October 5, 2026

CIP Project T-57 – SR 169 Pedestrian Bridge

This Addendum, including all attachments and referenced documents, amends the bid documents for the aforementioned project.

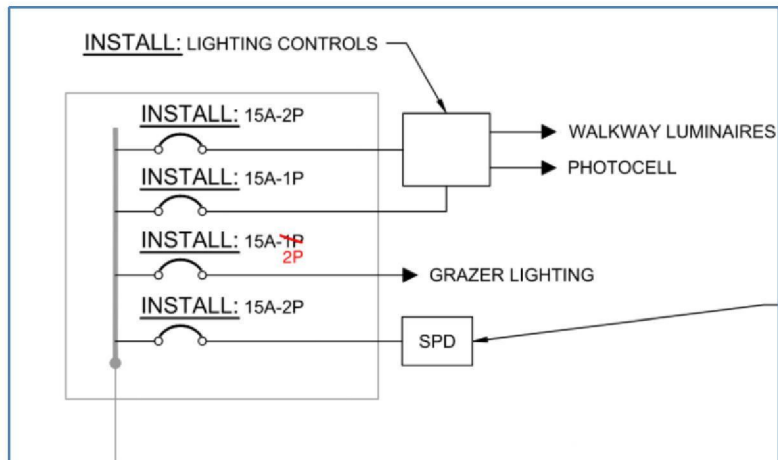
- 2.11 For the grazer lighting wiring called out on the electrical drawings, the wiring shall be updated as follows. All instances referring to “2#6 grazer lighting” shall be updated to “3#10 grazer lighting” on the plans.

LEGEND	
	PEDESTRIAN WALKWAY LIGHTING UNDER BRIDGE CANOPY
	UNDER RAMP LIGHTING
	PEDESTRIAN WALKWAY LIGHTING POLE C/W 2 LUMINAIRES
PWR	COMM
PWR	COMM
CAMERAS	
	3#6 WALKWAY LIGHTING, ~~2#6~~ 3#10 GRAZER LIGHTING & 1#8 GROUND
	3#6 WALKWAY LIGHTING & 1#8 GROUND
	2#10 GRAZER LIGHTING & 1#10 GROUND
	1-1/2" COMM CONDUIT (UNLESS OTHERWISE NOTED)
LTFMC	LIQUID TIGHT FLEXIBLE METALLIC CONDUIT
GRC	GALVANIZED RIGID CONDUIT
R	LUMINAIRE ON RED PHASE CONDUCTOR
B	LUMINAIRE ON BLACK PHASE CONDUCTOR
